COA (SP) 2025-021  
October 16, 2025

**STAFF REPORT  
ACCELERATED SPECIAL CERTIFICATE OF APPROPRIATENESS  
FOR THE PROPERTY AT  
607 UNIVERSITY DRIVE  
A LOCAL HISTORIC LANDMARK**

**Proposal:** The application requests design approval for additions and alterations to the residence and sitework.

**Figure 2: Current photo, 2025**

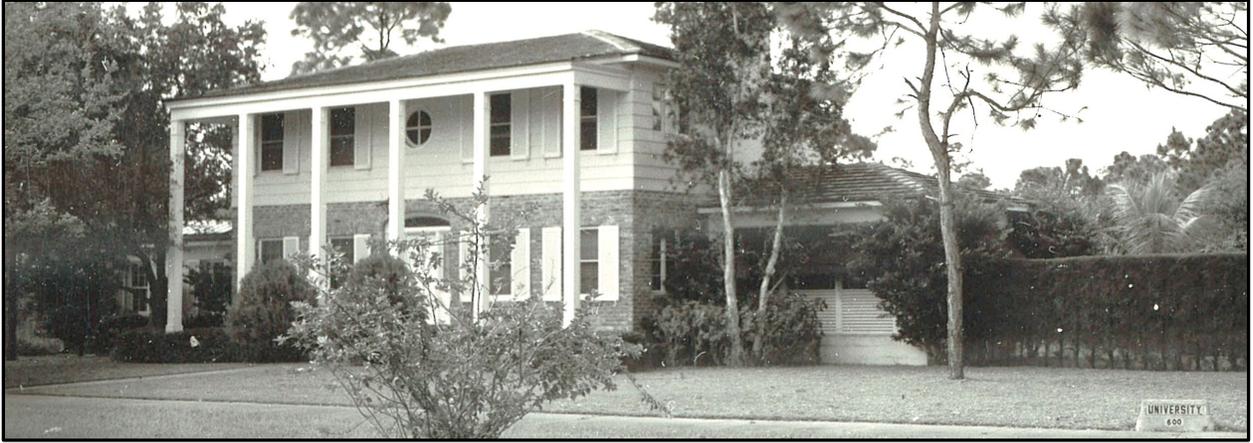
- New loggias with open-air second-story terraces to the rear of the original home and to the northeast of the second-story addition.
- Raising the hipped roof over the original garage (one-story wing to the left of the two-story volume in Figure 2) to match the ridge height of the original screened porch (one-story wing to the right of the two-story volume in Figure 2).
- Addition of French doors and porthole window at the rear (northwest) façade.
- Addition and resizing of windows at the side (southwest) façade.
- Partial interior remodeling.
- Sitework is limited to the relocation of an existing tree, reconfiguration of the existing Escobar Avenue driveway, and removal of a step feature at the existing spa.

Figures 3: Copper-capped solar water tank “chimney” at garage roof, 2025 (left); permit drawings (right)

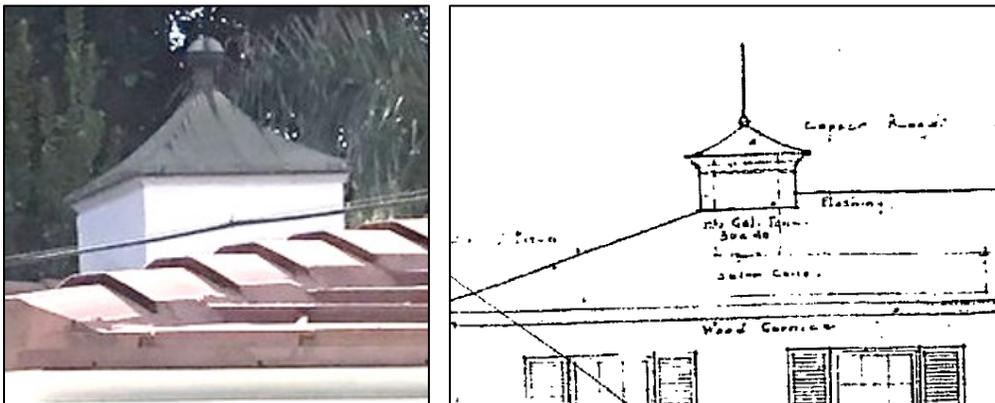
1. Window and door glass is to be clear, no tint, no reflectivity, no low-e.
2. Muntins are to be high-profile.
3. French doors are to receive higher kickplates.
4. Reintroduce the solar water tank “chimney” at the original location (see Figures 3).
5. Stucco portions of existing house is not to be restuccoed in its entirety.
6. Brick is not to be painted.
7. Wood siding is to remain.
8. Clarify siding material at new additions – wood or stucco to mimic siding?
9. Roof tile is to be flat “red” tile to match existing.
10. Clarify materials and colors of details – garage door, new columns, new gate at the covered loggia, railings, stucco texture, etc.
11. Study the matching porthole window at the front façade of the second story addition so that it does not mimic the existing house.
